**EARLY DESIGN GUIDANCE 2**

**9218 18th Ave SW  
Seattle, WA 98106**

**SDCI PROJECT NO.:**

3036383-LU  
3036384-LU  
3036524-EG

Option 5 (Preferred)

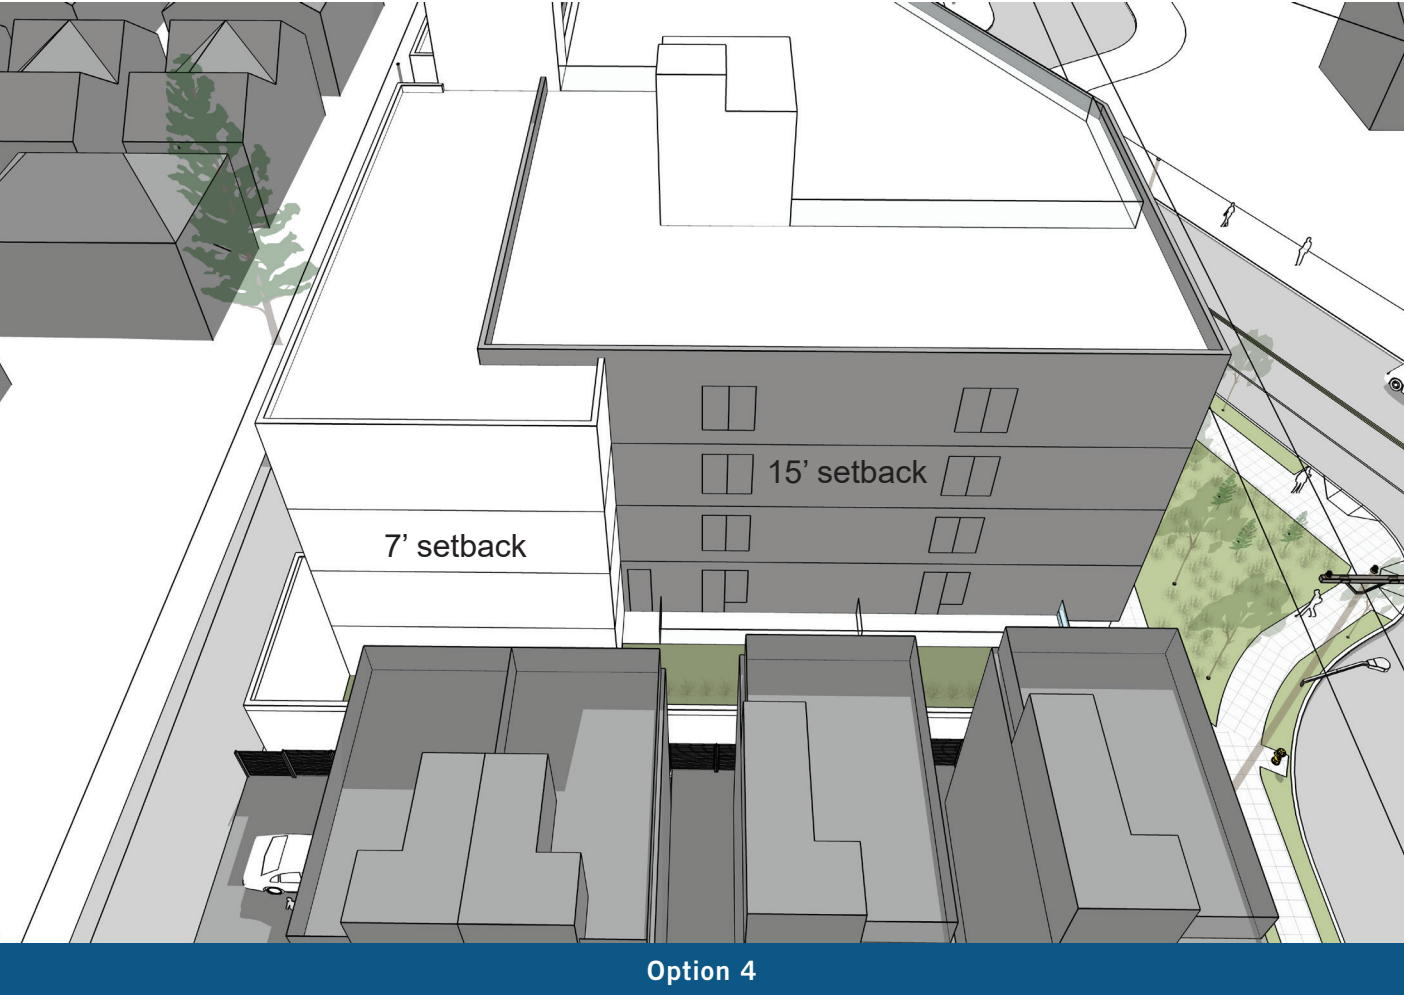
1.c. The Board discussed the proposal’s attempts to relate to the townhomes north of the site and observed that this design direction seemed to be the source of some of the less harmonious aspects of the design. The Board recommended instead that the applicant plan for and embrace the future context of Delridge Way SW, which is likely to consist of many large-scale multi-family buildings and a more urban context. (CS3-A-4)

**RESPONSE:** Although the site to the south is unlikely to be fully developed due to its irregular triangle shape, this option does account for the potential of a building being developed. The continuous facade along 18th Ave SW and Delridge Way SW creates a balanced and strong ‘Urban Edge’ that reflects the grid shift and the future context of the site.

**RESPONSE:** Although the site to the south is unlikely to be fully developed due to its irregular triangle shape, this option does account for the potential of a building being developed. The mass that fronts Delridge Way SW provides a strong ‘Urban Edge’ that reflects the future context of the site, while the set back mass on 18th Ave SW creates a hierarchy in the massing that reflects the residential street.

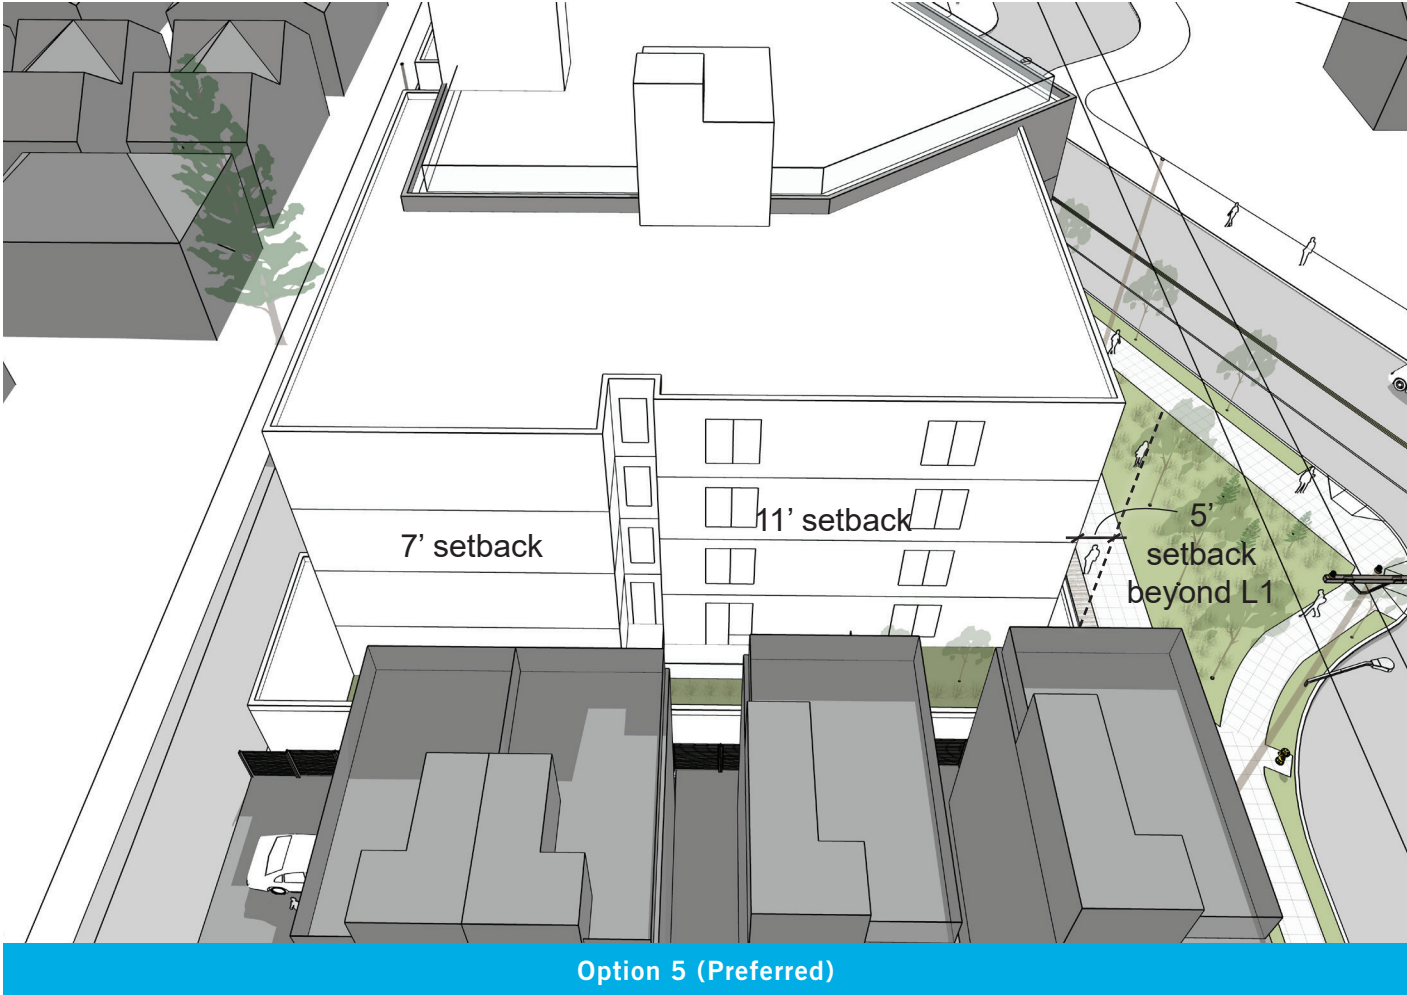
1.d. The Board was particularly concerned about the large expanses of blank wall proposed on the north and south facades. The Board directed the applicant to integrate glazing into these facades to reduce the impacts associated with the blank walls and to improve solar access for residents. At the next EDG meeting, show fenestration for each proposed massing model. (CS1-B-2, DC2-B-2)

**RESPONSE:** This option divides the north facade into two masses to prevent an expanse of blank wall. The 15’ setback from the north property line allows the integration of fenestration on the facade. Carefully located windows reduce the chance for privacy concerns for both the building tenants and the adjacent townhouses.

**RESPONSE:** This option divides the north facade into two masses to prevent an expanse of blank wall. The 10’ setback from the north property line allows the integration of fenestration on the facade. A recess at the intersection of the corridor and north facade allows for additional fenestration. The addition of a 5’ setback, above L1, on the western facade allows for additional natural light and air to reach the townhouse. Carefully located windows reduce the chance for privacy concerns for both the building tenants and the adjacent townhouses.

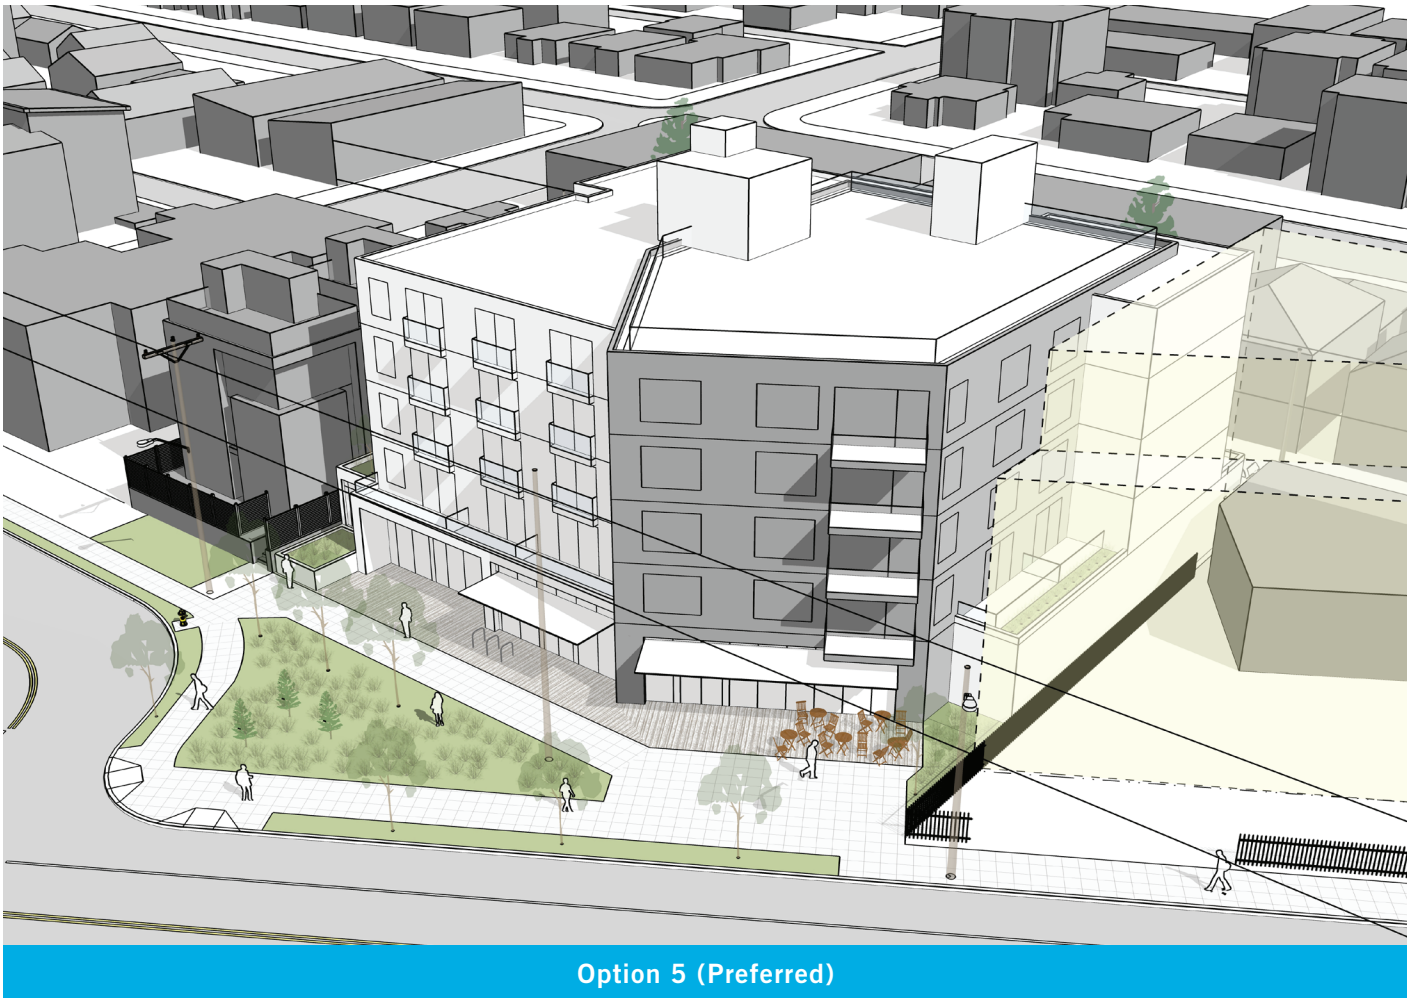
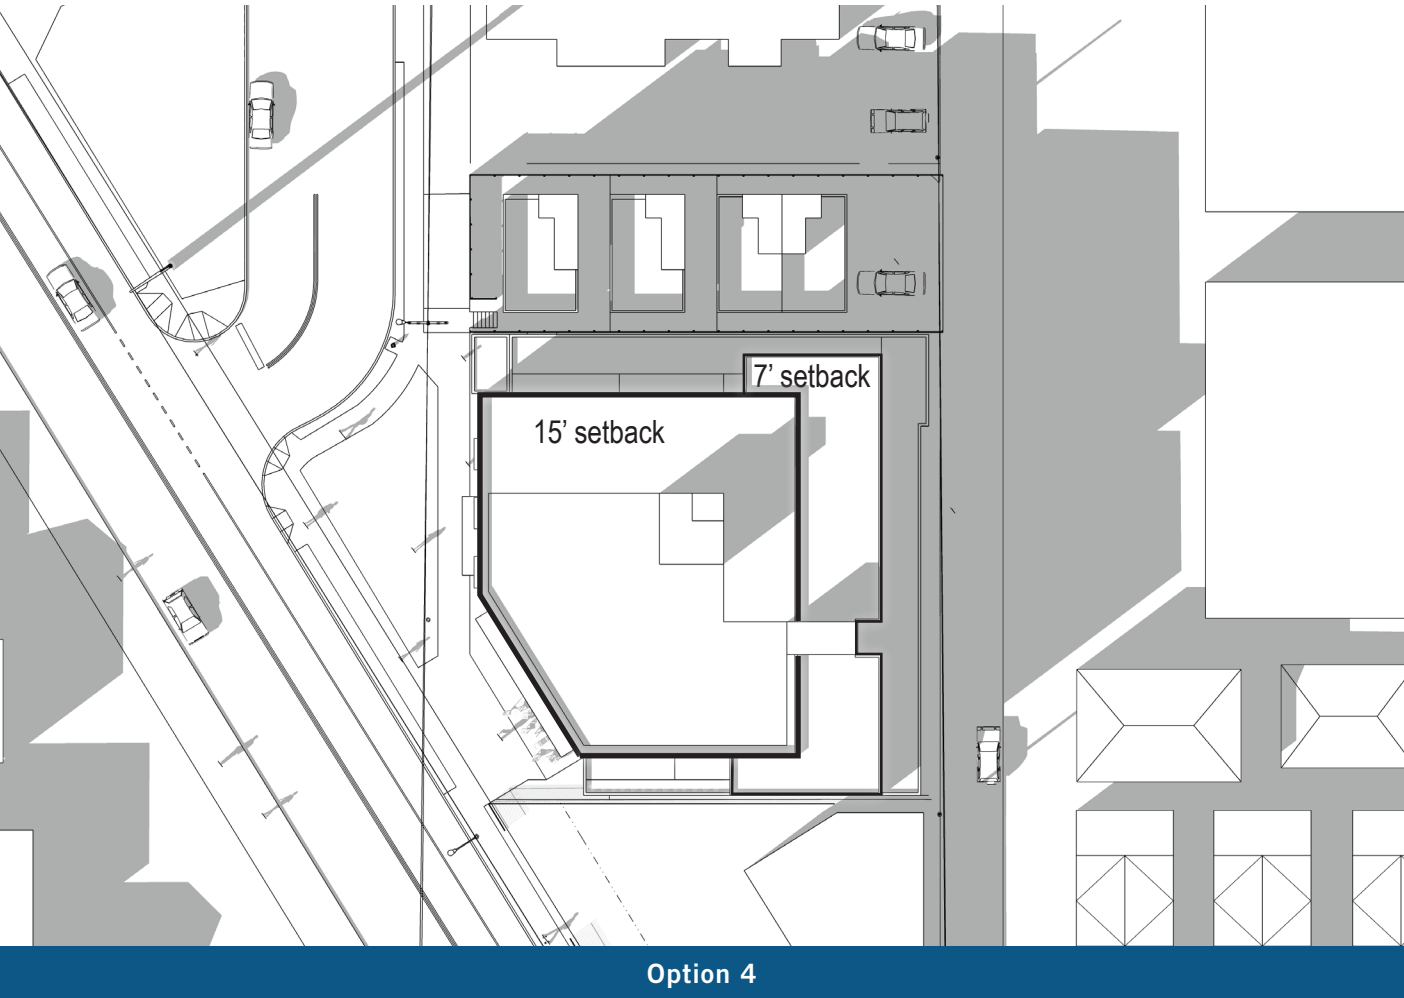
2.a. The Board noted that the blank wall condition of the south façade results in reduced solar access for the residential units. As the design is further developed, keep internal solar access in mind and allow this consideration to inform the overall design concept and internal layout. (CS1-B-2, DC2-B-2)

**RESPONSE:** This option strikes a balance between maximizing natural light and air to penetrate all units, while acknowledging the townhouses to the north and the potential southern site development. This is accomplished by having the majority of unit fenestrations face the site street and alley. Along the north and south facades, setbacks are utilized to allow for fenestration while providing mutual relief for the building and adjacent sites.

**RESPONSE:** This option strikes a balance between maximizing natural light and air to penetrate all units, while acknowledging the townhouses to the north and the potential southern site development. This is accomplished by having the majority of unit fenestrations face the site street and alley. Along the north and south facades, setbacks are utilized to allow for fenestration while providing mutual relief for the building and adjacent sites.

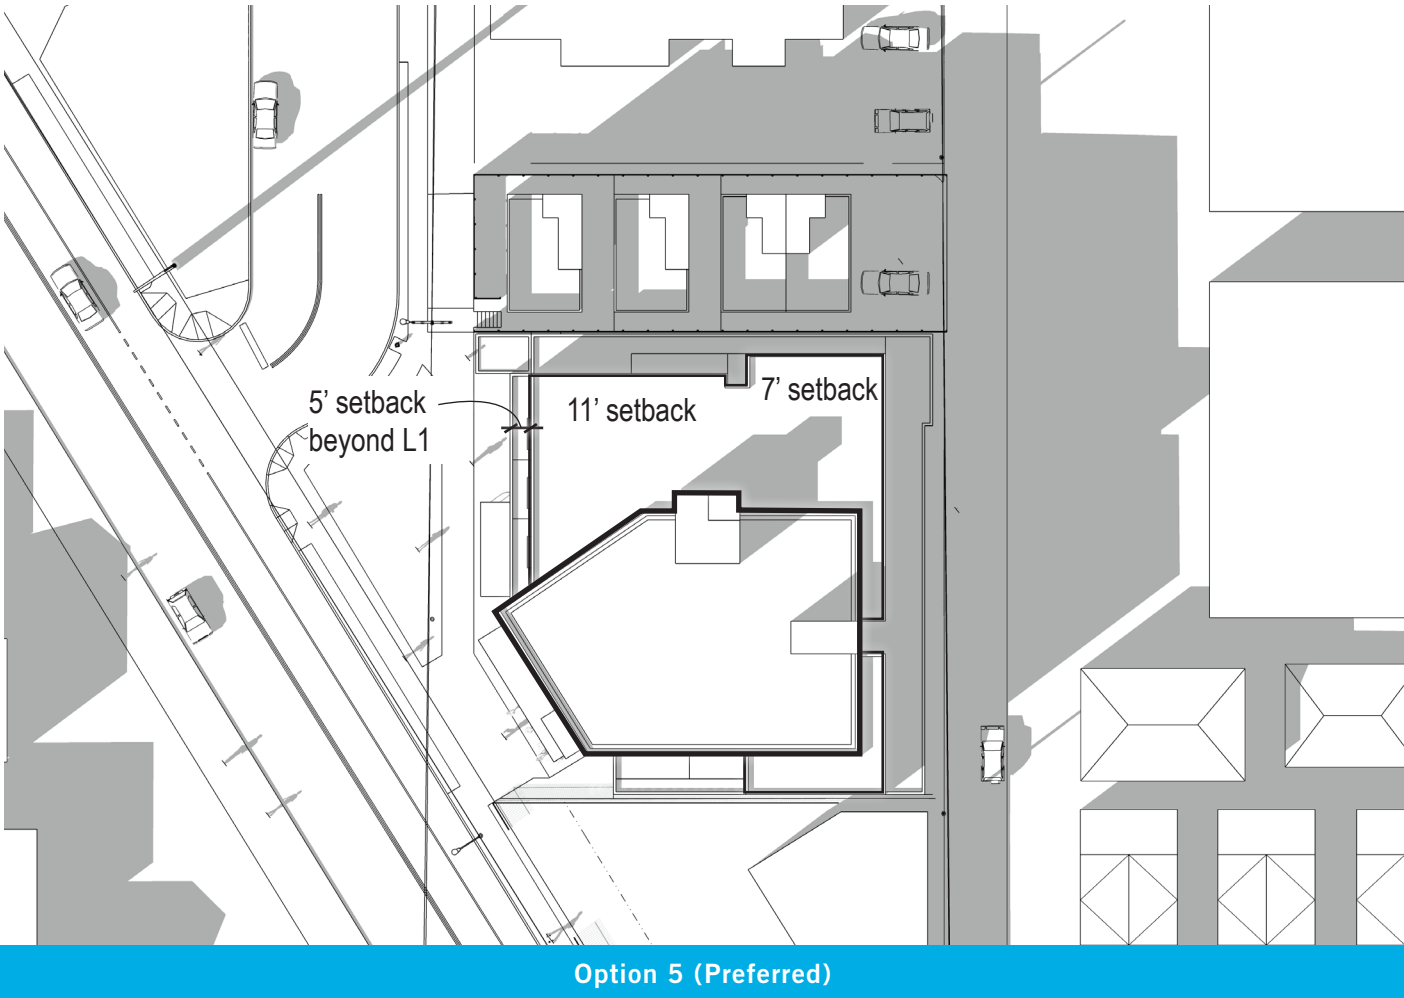
2.b. The Board recommended setting back the upper levels to improve solar access for neighboring properties. (CS1-B-2)

**RESPONSE:** When compared to Option 5, the proposed additional 4’ setback on the NW upper facade of the building doesn’t noticeably reduce the shadows cast onto the existing townhouses. Additionally, the SW upper portion of the building is set back 11’-0” to allow for natural light and air penetration even with the potential of the southern site development.

**RESPONSE:** The proposed 11’ setback on the NW upper facade of the building gives relief to the adjacent townhouses. A 7’ setback on the west facade creates additional space for natural light and air penetration. When compared to Option 4, the shadows cast are similar. Additionally, the SW upper portion of the building is set back 11’-6” to allow for natural light and air penetration even with the potential of the southern site development.
